Access Compliance Report

Public Rights-of-Way

(Pedestrian Signals)

Intersection ID: N/A	Main Street:	Cross Street: N/A	Location: N/A
ADA ID: 13E0B9F18EB1	Signal Type: Two Push Buttons-Non APS	Overall Compliance: No	Severity Score: BTN 1:N/A BTN 2: N/A No BTN: N/A
Codes/Mitigation Info/Possible Solution		Field Measurements/Component Compliance

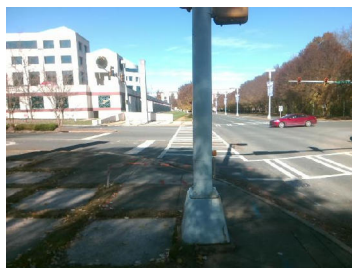
Compliance	Description	Data	Compliance	Description	Data
	Button Count	Button2	N/A	Distant to Additional Button (in)	N/A
	Additional Button Present?	No		Additional Button ID	N/A
N/A	Signal Buttons Required?	N/A	N/A	Additional Ped Posts Required	N/A
	How Many Ped Street Xings?	2		Located In An Island/Median?	No
N/A	B 1 Sign Present?	Yes	N/A	B 2 Sign Present?	Yes
Yes	B 1 Sign Purpose?	Yes	Yes	B 2 Sign Purpose?	Yes
Yes	B 1 Sign Lettering & Contrast?	Yes	Yes	B 2 Sign Lettering & Contrast?	Yes
Yes	B 1 Parallel To XWalk?	Yes	Yes	B 2 Parallel To XWalk?	Yes
Yes	B 1 PAR to Button?	Yes	Yes	B 2 PAR to Button?	Yes
Yes	B 1 PAR to XWalk?	Yes	Yes	B 2 PAR to XWalk?	Yes
Yes	B 1 Clear Floor Space?	Yes	Yes	B 2 Clear Floor Space?	Yes
N/A	B 1 FWD Approach?	Yes	N/A	B 2 FWD Approach?	Yes
N/A	B 1 FWD Approach Constrained?	No	N/A	B 2 FWD Approach Constrained?	No
No	B 1 FWD Approach Reach (in)	6.0	No	B 2 FWD Approach Reach (in)	6.0

N/A	B 1 FWD Approach Width (in)	N/A	N/A	B 2 FWD Approach Width (in)	N/A
N/A	B 1 FWD Approach Obstruction?	Yes	N/A	B 2 FWD Approach Obstruction?	Yes
N/A	B 1 FWD Approach Obstruction Dist (in)	0.0	N/A	B 2 FWD Approach ObstructionDist (in)	0.0
N/A	B 1 PARA Approach?	Yes	N/A	B 2 PARA Approach?	Yes
N/A	B 1 PARA Approach Constrained?	No	N/A	B 2 PARA Approach Constrained?	No
Yes	B 1 PARA Approach Reach (in)	6.0	Yes	B 2 PARA Approach Reach (in)	6.0
N/A	B 1 PARA Approach Width (in)	N/A	N/A	B 2 PARA Approach Width (in)	N/A
N/A	B 1 PARA Approach Obstruction?	Yes	N/A	B 2 PARA Approach Obstruction?	Yes
N/A	B 1 PARA Approach Obstruction Dist (in)	0.0	N/A	B 2 PARA Approach ObstructionDist (in)	0.0
No	B 1 Clear Floor Space Slope (%)	2.3	Yes	B 2 Clear Floor Space Slope (%)	0.9
Yes	B 1 Clear Floor Space XSlope (%)	0.9	Yes	B 2 Clear Floor Space XSlope (%)	1.6
N/A	B 1 PAR Slope (%)	2.1	N/A	B 2 PAR Slope (%)	1.5
No	B 1 Height (in)	50.0	No	B 2 Height (in)	50.0

Yes	B 1 Clear Xing Direction?	ClearlyMarked	Yes	B 2 Clear Xing Direction?	ClearlyMarked
	B 1 Crossing Direction	To NE		B 2 Crossing Direction	To N
No	B 1 DistanceTo XWalk (in)	140.0	Yes	B 2 DistanceTo XWalk (in)	0.0
Yes	B 1 DistanceTo Curb (in)	66.0	Yes	B 2 DistanceTo Curb (in)	71.0
Yes	B 1 Diameter (in)	2.0	No	B 2 Diameter (in)	2.0

Possible Solutions: Replace Signal Push Button With APS Button on New Post. Remove & Relocate Sign. Adjust Signal Button Height. Provide Push Button Extension.
